Project Title
T1 VITA LIVING

Project Title
UNION, ST. JOHNS

TABLE OF CHANGES FOR PLANNING AMENDMENTS

SUMMARY OF CHANGES BETWEEN CONSENTED PLANNING DRAWINGS FOR APPLICATIONS REF.'S 125655/FO/2019 AND 131175/NMC/2021 AND RESUBMITTED PROPOSED NMA APPLICATION DRAWINGS.

Drawing Title
TYPICAL FACADE DETAILS LEVEL 01

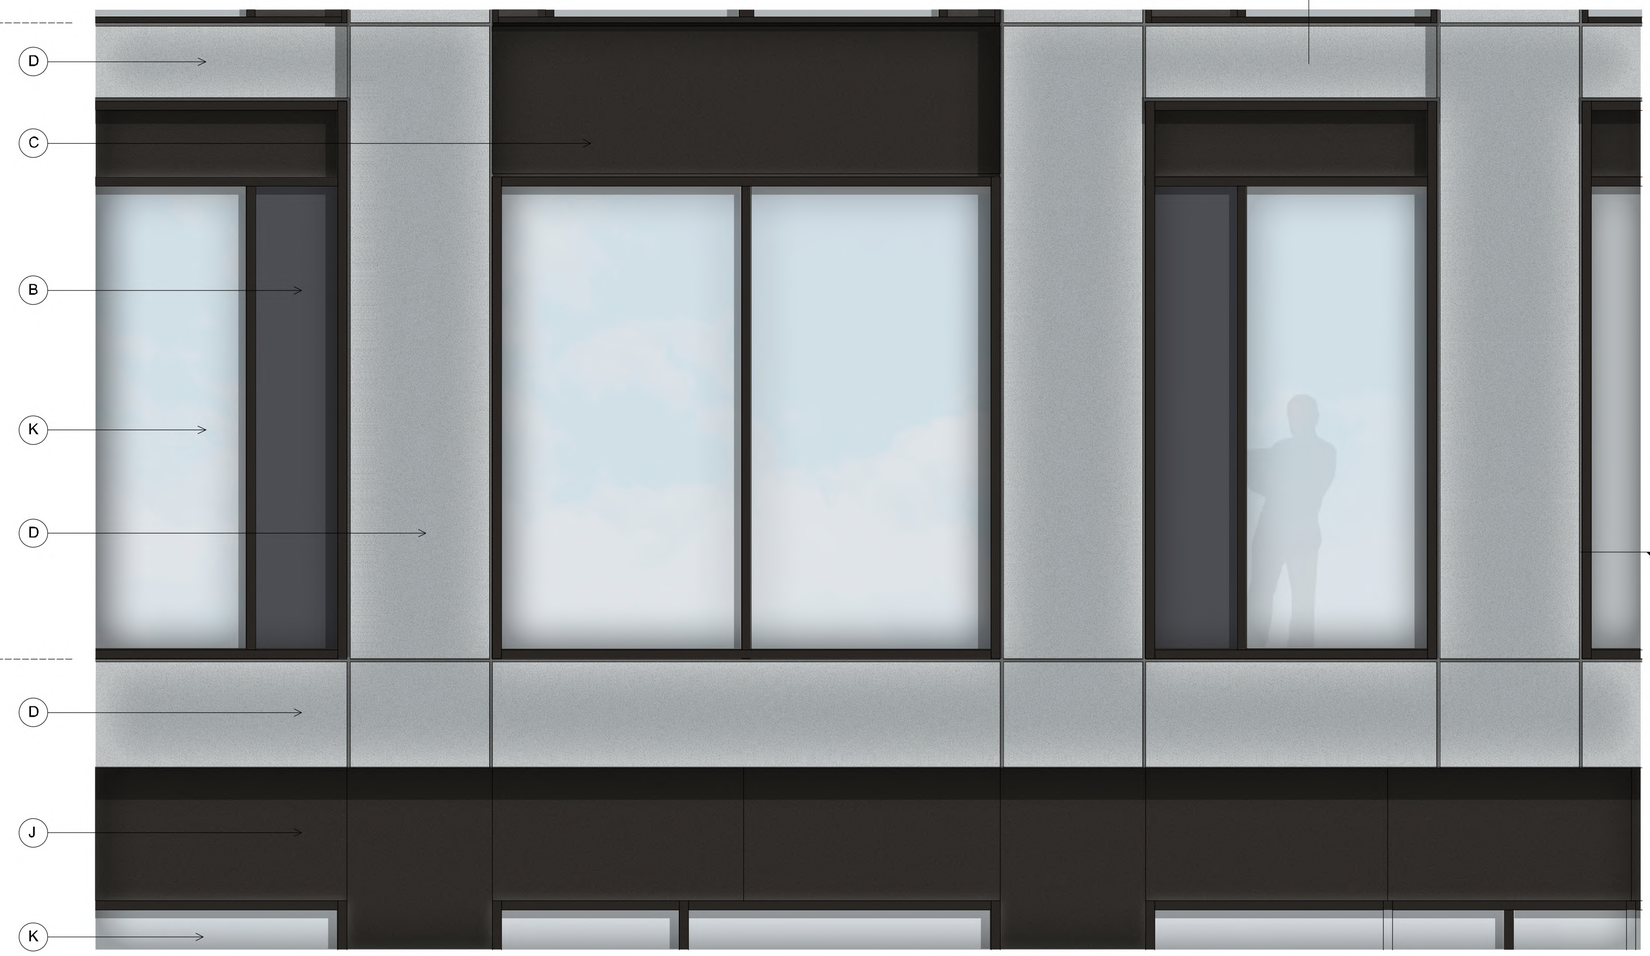
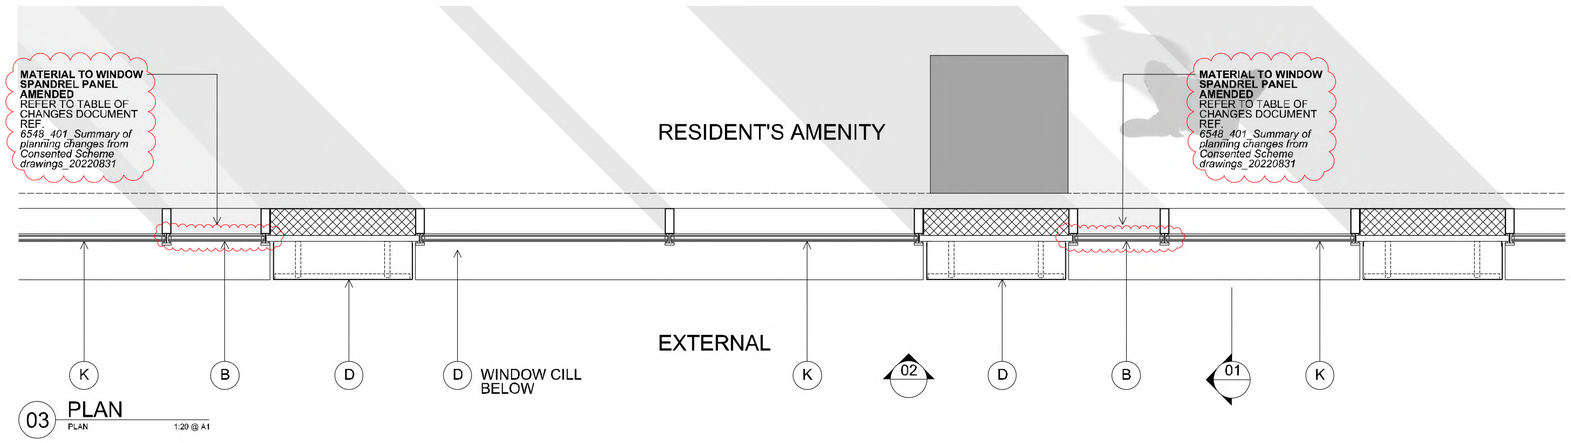
No.	Date	Dwn	Chk	App	Revision or reason for issue
-	20191011	PT	PT	JR	First issue DRAFT PLANNING ISSUE
A	20191025	JG	GS	JR	PLANNING ISSUE.
B	20200311	CM	GS	JR	REISSUED FOR PLANNING Reissued to reflect current proposals
C	20210331	JG	GS	JR	ISSUED FOR PLANNING
D	20220126	GS	GS	JR	REISSUED FOR PLANNING Drawing updated to reflect proposed changes to façade at Level 01. Changes highlighted in red

REVISION CLOUDS DENOTE EXTENT OF CHANGE SINCE THE PREVIOUS REVISION OF THIS DRAWING

Drawing Title
EAST ELEVATION

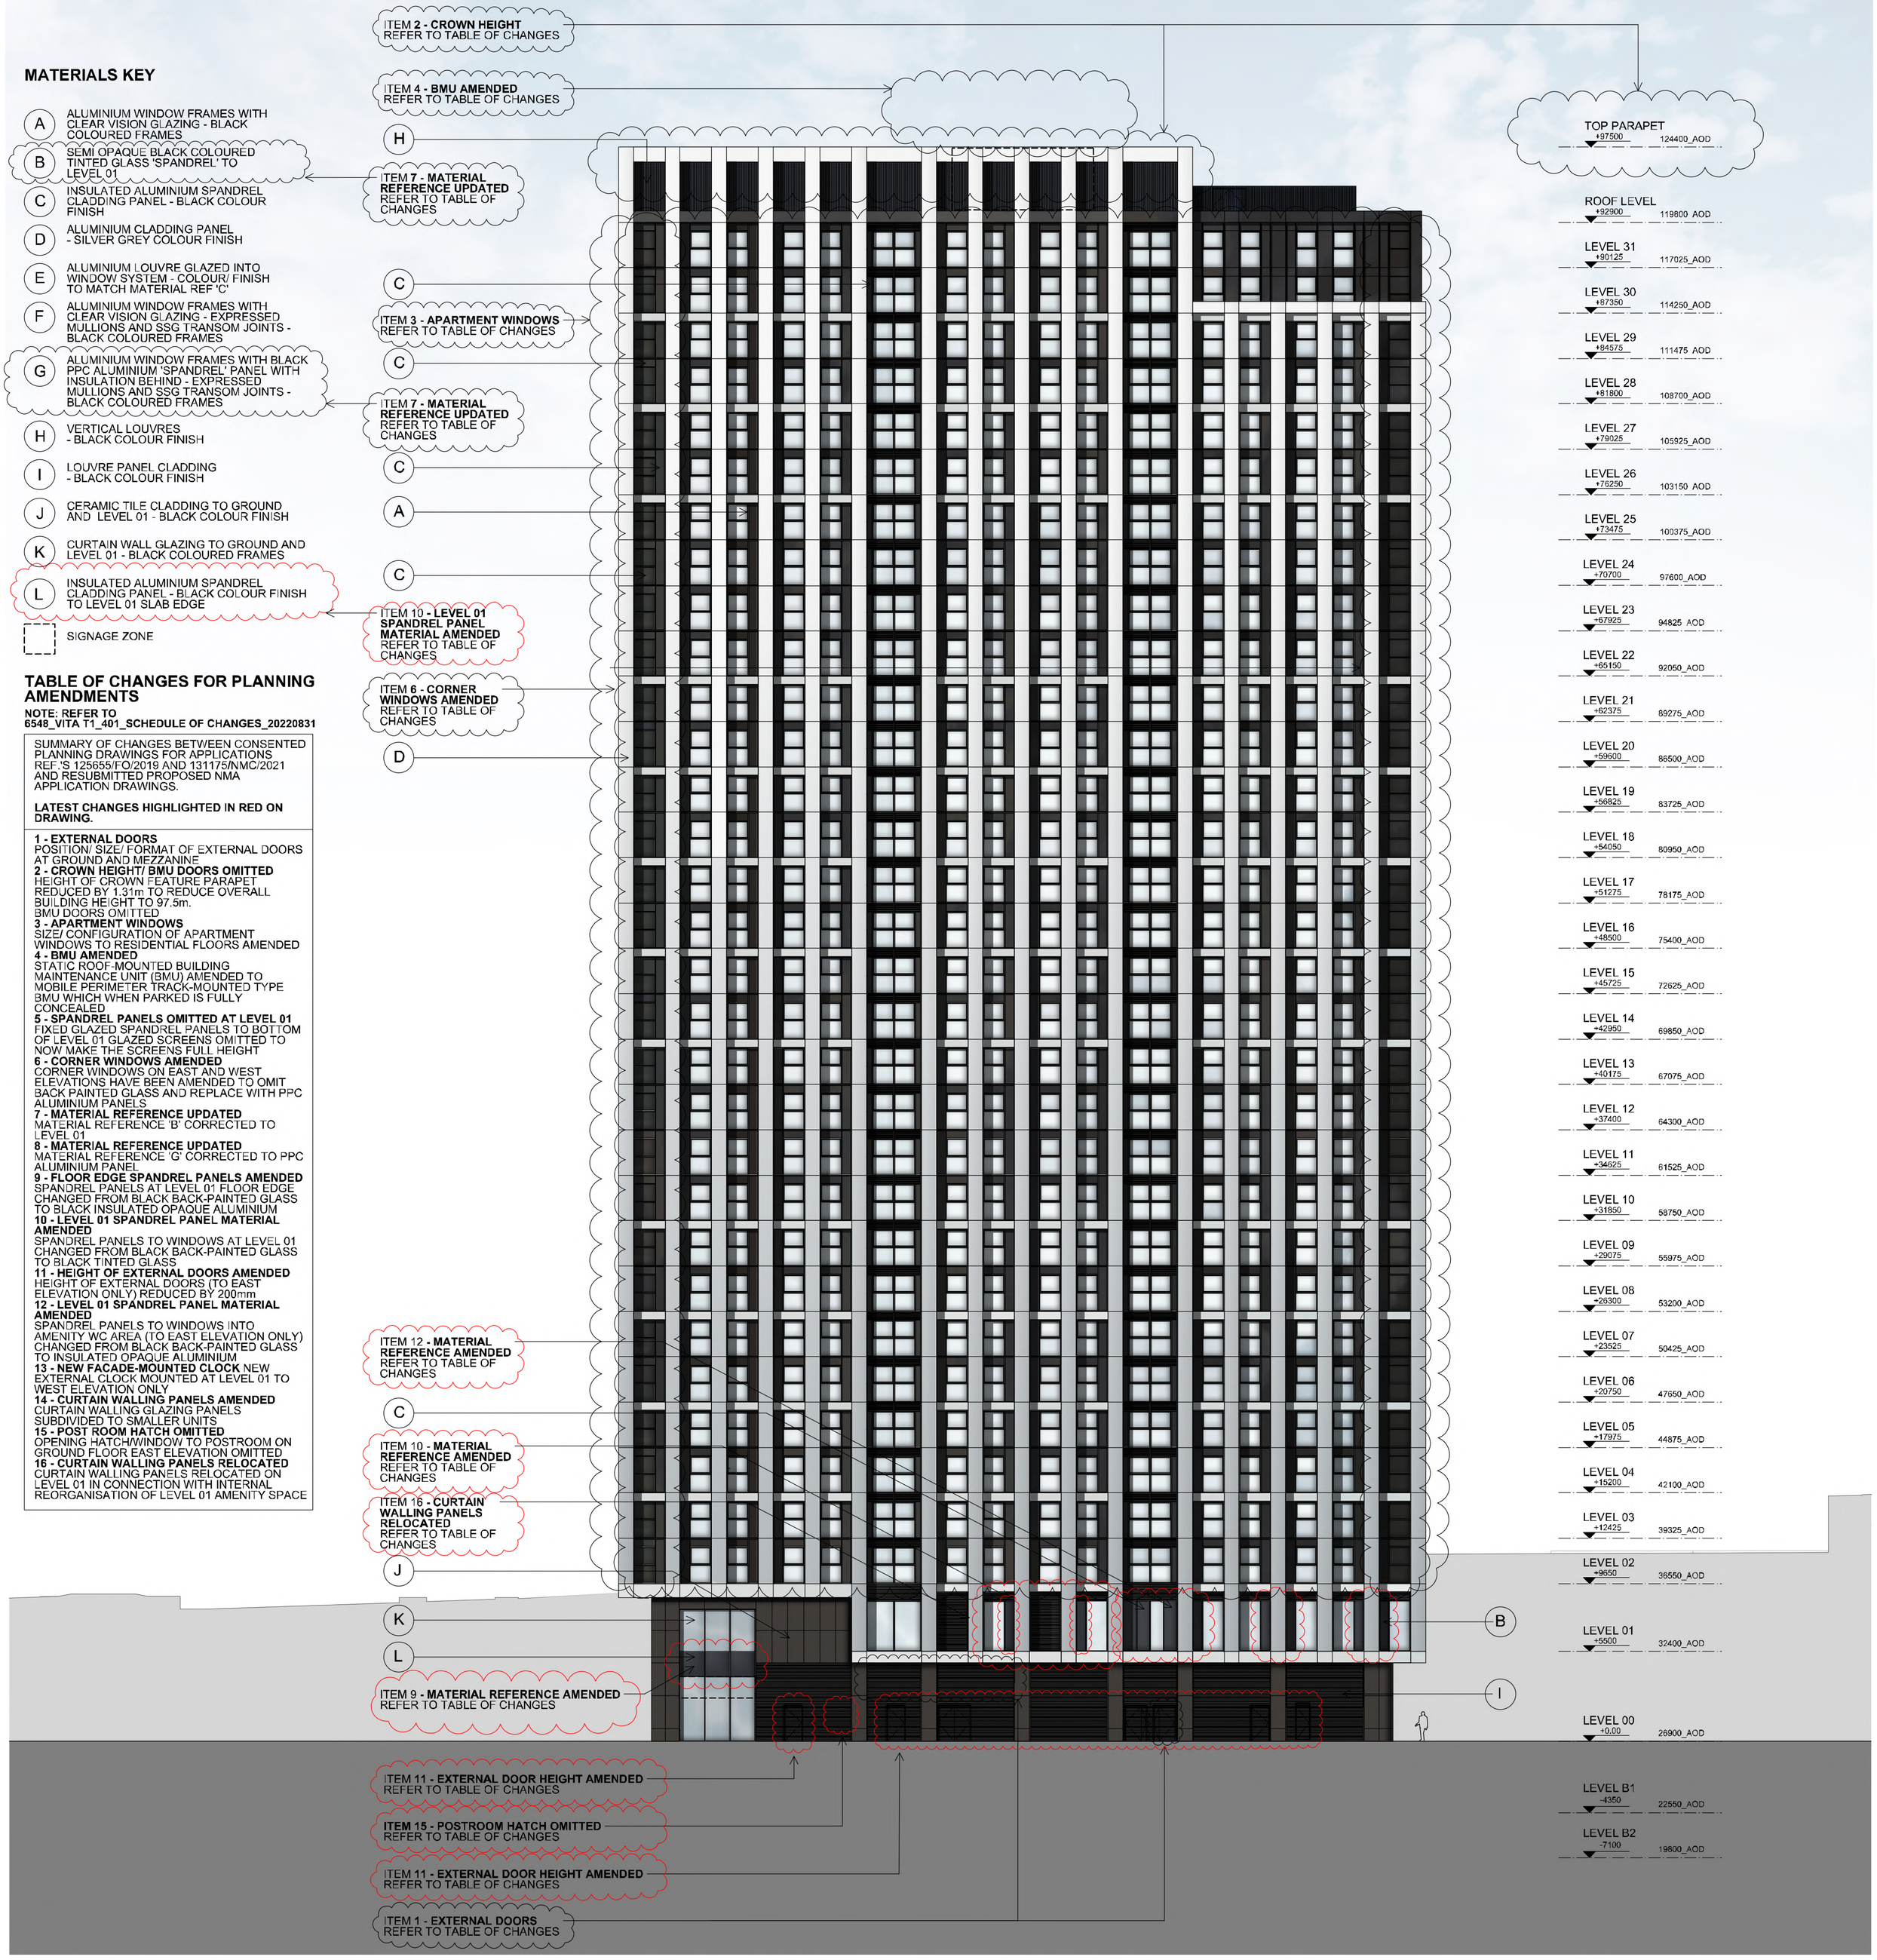
ITEM **2 - CROWN HEIGHT/ BMU DOORS** REFER TO TABLE OF CHANGES

ITEM **4 - BMU AMENDED** REFER TO TABLE OF CHANGES

ITEM **7 - MATERIAL REFERENCE UPDATED** REFER TO TABLE OF CHANGES

ITEM **3 - APARTMENT WINDOWS** REFER TO TABLE OF CHANGES

ITEM **5 - SPANDREL PANELS OMITTED AT LEVEL 01** REFER TO TABLE OF CHANGES

ITEM **14 - CURTAIN WALLING AMENDED** REFER TO TABLE OF CHANGES

1 - EXTERNAL DOORS
POSITION/ SIZE/ FORMAT OF EXTERNAL DOORS AT GROUND AND MEZZANINE
2 - CROWN HEIGHT/ BMU DOORS OMITTED
HEIGHT OF CROWN FEATURE PARAPET REDUCED BY 1.31m TO REDUCE OVERALL BUILDING HEIGHT TO 97.5m.
BMU DOORS OMITTED
3 - APARTMENT WINDOWS
SIZE/ CONFIGURATION OF APARTMENT WINDOWS TO RESIDENTIAL FLOORS AMENDED
4 - BMU AMENDED
STATIC ROOF-MOUNTED BUILDING MAINTENANCE UNIT (BMU) AMENDED TO MOBILE PERIMETER TRACK-MOUNTED TYPE BMU WHICH WHEN PARKED IS FULLY CONCEALED
5 - SPANDREL PANELS OMITTED AT LEVEL 01
FIXED GLAZED SPANDREL PANELS TO BOTTOM OF LEVEL 01 GLAZED SCREENS OMITTED TO NOW MAKE THE SCREENS FULL HEIGHT
6 - CORNER WINDOWS AMENDED
CORNER WINDOWS ON EAST AND WEST ELEVATIONS HAVE BEEN AMENDED TO OMIT BACK PAINTED GLASS AND REPLACE WITH PPC ALUMINIUM PANELS
7 - MATERIAL REFERENCE UPDATED
MATERIAL REFERENCE 'B' CORRECTED TO LEVEL 01
8 - MATERIAL REFERENCE UPDATED
MATERIAL REFERENCE 'G' CORRECTED TO PPC ALUMINIUM PANEL

9 - FLOOR EDGE SPANDREL PANELS AMENDED
SPANDREL PANELS AT LEVEL 01 FLOOR EDGE CHANGED FROM BLACK BACK-PAINTED GLASS TO BLACK INSULATED OPAQUE ALUMINIUM
10 - LEVEL 01 SPANDREL PANEL MATERIAL AMENDED
SPANDREL PANELS TO WINDOWS AT LEVEL 01 CHANGED FROM BLACK BACK-PAINTED GLASS TO BLACK TINTED GLASS
11 - HEIGHT OF EXTERNAL DOORS AMENDED
HEIGHT OF EXTERNAL DOORS (TO EAST ELEVATION ONLY) REDUCED BY 200mm
12 - LEVEL 01 SPANDREL PANEL MATERIAL AMENDED
SPANDREL PANELS TO WINDOWS INTO AMENITY WC AREA (TO EAST ELEVATION ONLY) CHANGED FROM BLACK BACK-PAINTED GLASS TO INSULATED OPAQUE ALUMINIUM
13 - NEW FACADE-MOUNTED CLOCK NEW EXTERNAL CLOCK MOUNTED AT LEVEL 01 TO WEST ELEVATION ONLY
14 - CURTAIN WALLING PANELS AMENDED
CURTAIN WALLING GLAZING PANELS SUBDIVIDED TO SMALLER UNITS
15 - POST ROOM HATCH OMITTED
OPENING HATCH/WINDOW TO POSTROOM ON GROUND FLOOR EAST ELEVATION OMITTED
16 - CURTAIN WALLING PANELS RELOCATED

CURTAIN WALLING PANELS RELOCATED ON LEVEL 01 IN CONNECTION WITH INTERNAL REORGANISATION OF LEVEL 01 AMENITY SPACE

Drawing Title
SOUTH ELEVATION

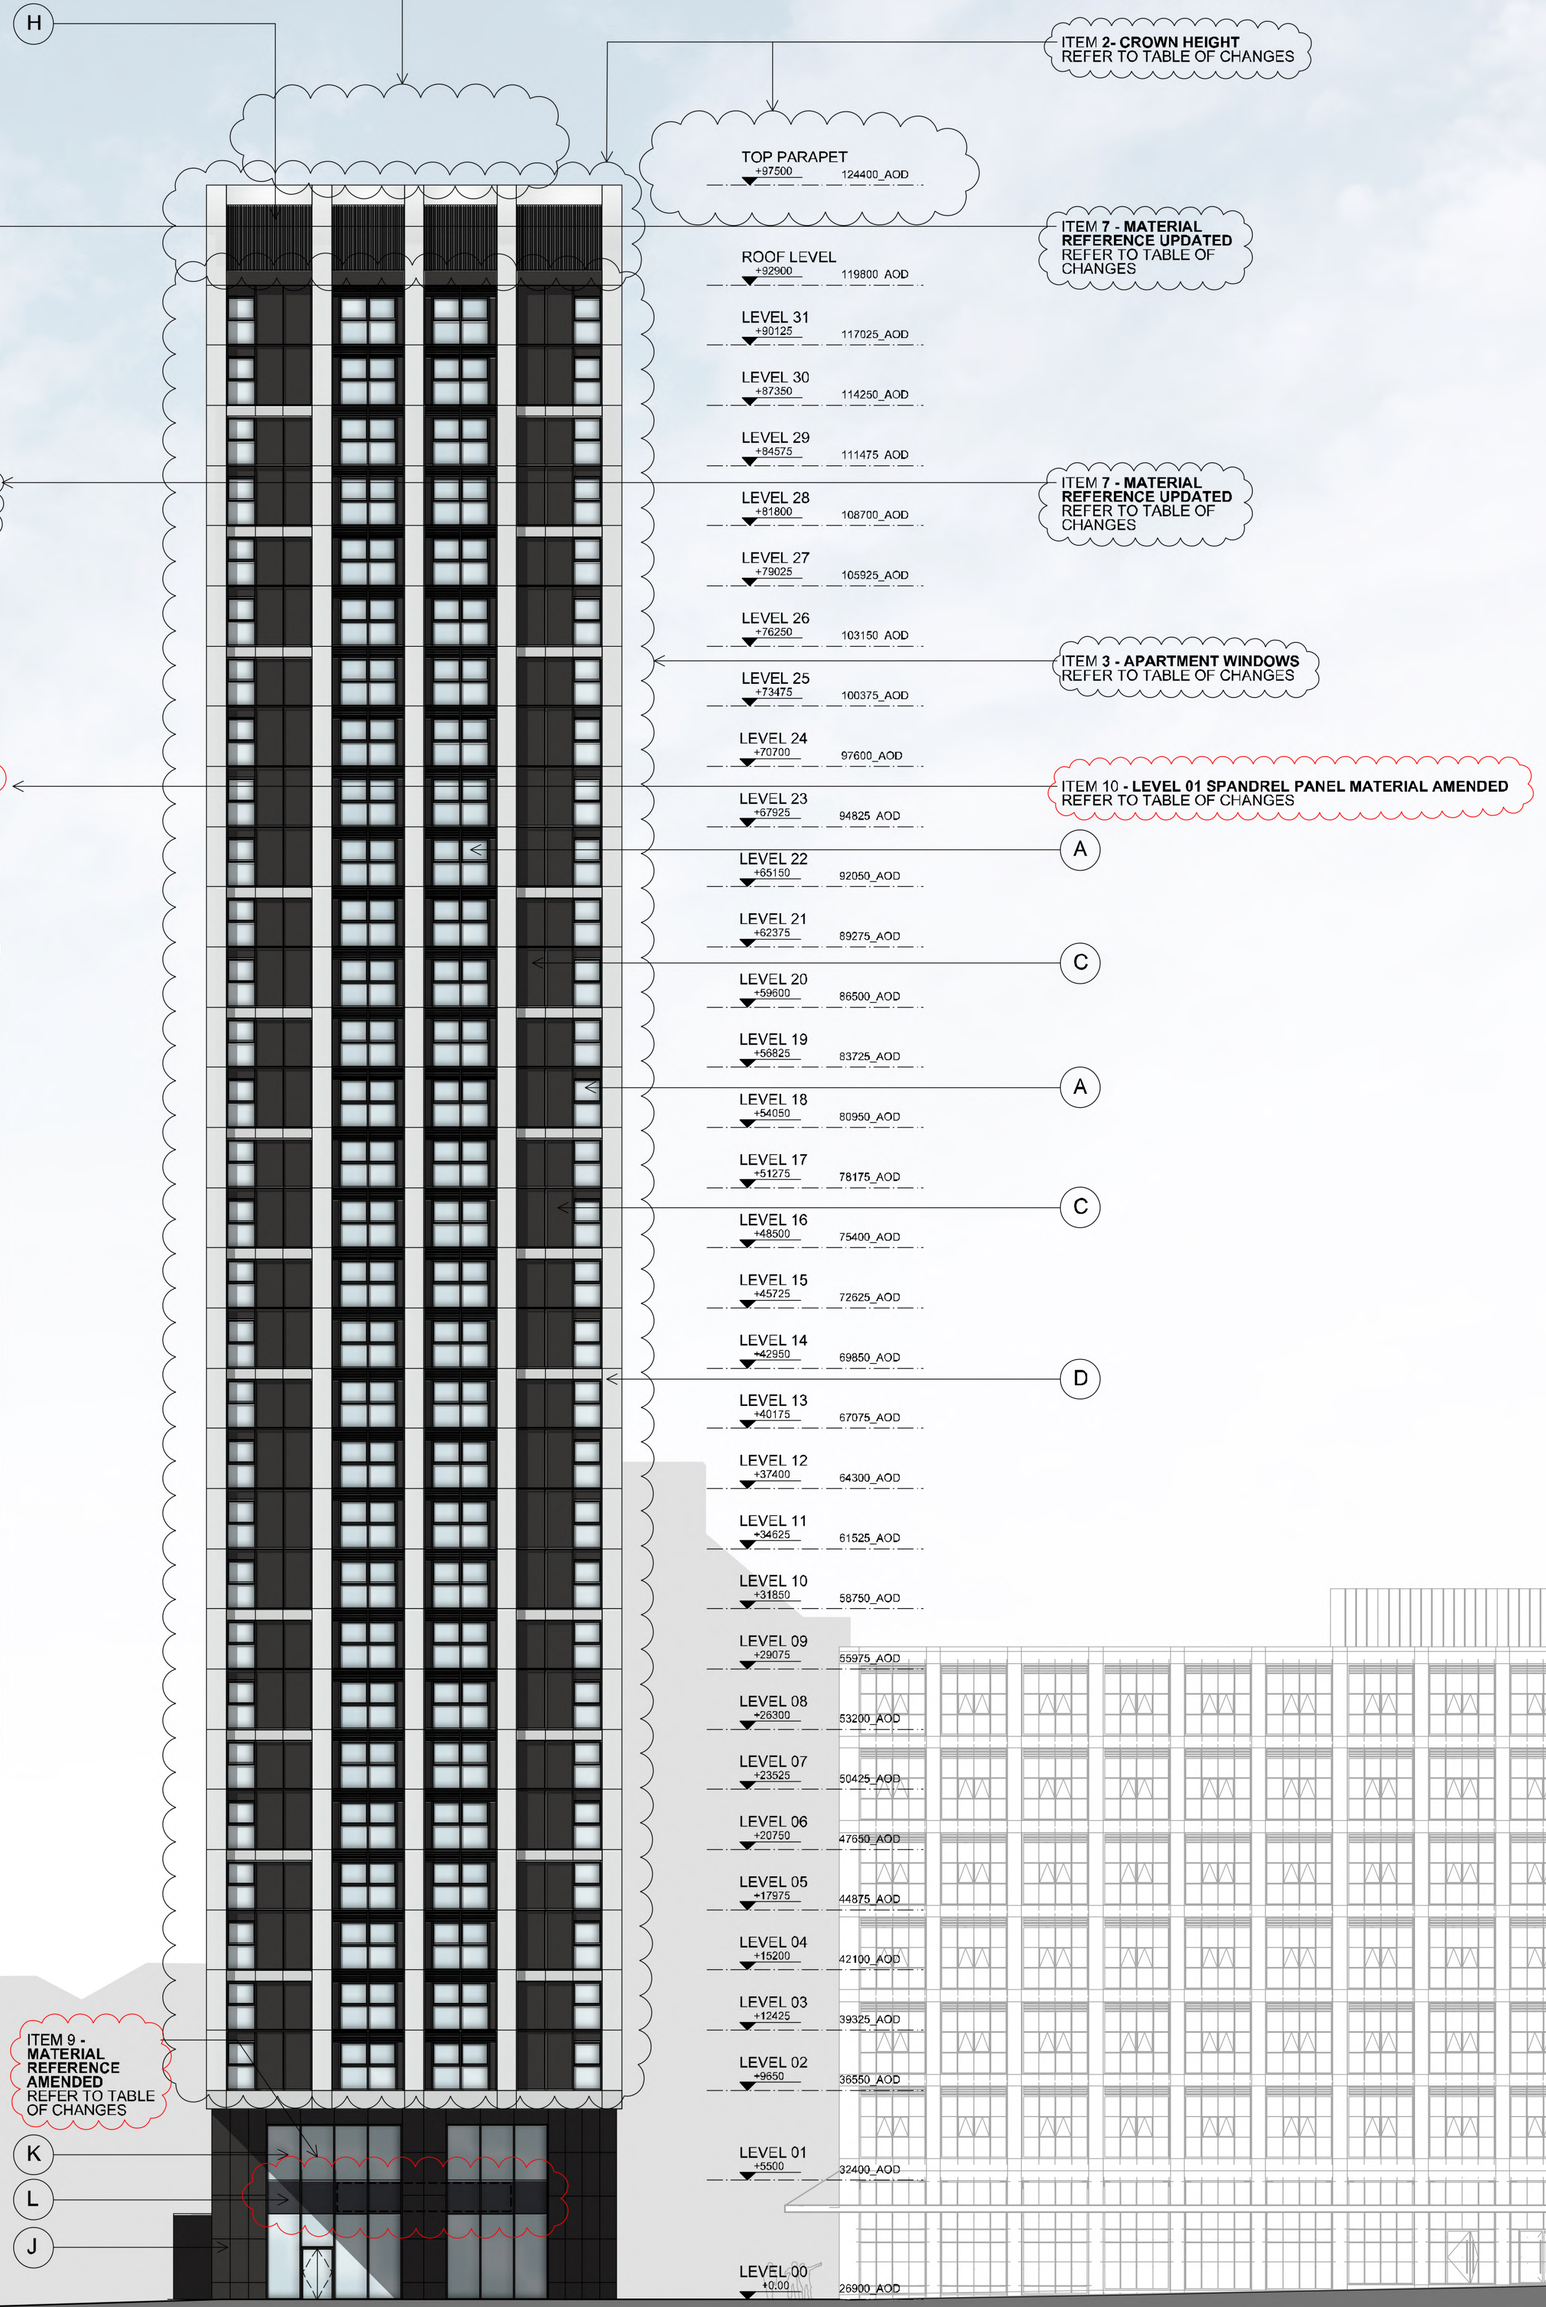
1 - EXTERNAL DOORS
POSITION/ SIZE/ FORMAT OF EXTERNAL DOORS AT GROUND AND MEZZANINE
2 - CROWN HEIGHT/ BMU DOORS OMITTED
HEIGHT OF CROWN FEATURE PARAPET REDUCED BY 1.31m TO REDUCE OVERALL BUILDING HEIGHT TO 97.5m.
BMU DOORS OMITTED
3 - APARTMENT WINDOWS
SIZE/ CONFIGURATION OF APARTMENT WINDOWS TO RESIDENTIAL FLOORS AMENDED
4 - BMU AMENDED
STATIC ROOF-MOUNTED BUILDING MAINTENANCE UNIT (BMU) AMENDED TO MOBILE PERIMETER TRACK-MOUNTED TYPE BMU WHICH WHEN PARKED IS FULLY CONCEALED
5 - SPANDREL PANELS OMITTED AT LEVEL 01
FIXED GLAZED SPANDREL PANELS TO BOTTOM OF LEVEL 01 GLAZED SCREENS OMITTED TO NOW MAKE THE SCREENS FULL HEIGHT
6 - CORNER WINDOWS AMENDED
CORNER WINDOWS ON EAST AND WEST ELEVATIONS HAVE BEEN AMENDED TO OMIT BACK PAINTED GLASS AND REPLACE WITH PPC ALUMINIUM PANELS
7 - MATERIAL REFERENCE UPDATED
MATERIAL REFERENCE 'B' CORRECTED TO LEVEL 01
8 - MATERIAL REFERENCE UPDATED
MATERIAL REFERENCE 'G' CORRECTED TO PPC ALUMINIUM PANEL

9 - FLOOR EDGE SPANDREL PANELS AMENDED
SPANDREL PANELS AT LEVEL 01 FLOOR EDGE CHANGED FROM BLACK BACK-PAINTED GLASS TO BLACK INSULATED OPAQUE ALUMINIUM
10 - LEVEL 01 SPANDREL PANEL MATERIAL AMENDED
SPANDREL PANELS TO WINDOWS AT LEVEL 01 CHANGED FROM BLACK BACK-PAINTED GLASS TO BLACK TINTED GLASS
11 - HEIGHT OF EXTERNAL DOORS AMENDED
HEIGHT OF EXTERNAL DOORS (TO EAST ELEVATION ONLY) REDUCED BY 200mm
12 - LEVEL 01 SPANDREL PANEL MATERIAL AMENDED
SPANDREL PANELS TO WINDOWS INTO AMENITY WC AREA (TO EAST ELEVATION ONLY) CHANGED FROM BLACK BACK-PAINTED GLASS TO INSULATED OPAQUE ALUMINIUM
13 - NEW FACADE-MOUNTED CLOCK NEW EXTERNAL CLOCK MOUNTED AT LEVEL 01 TO WEST ELEVATION ONLY
14 - CURTAIN WALLING PANELS AMENDED
CURTAIN WALLING GLAZING PANELS SUBDIVIDED TO SMALLER UNITS
15 - POST ROOM HATCH OMITTED
OPENING HATCH/WINDOW TO POSTROOM ON GROUND FLOOR EAST ELEVATION OMITTED
16 - CURTAIN WALLING PANELS RELOCATED

CURTAIN WALLING PANELS RELOCATED ON LEVEL 01 IN CONNECTION WITH INTERNAL REORGANISATION OF LEVEL 01 AMENITY SPACE
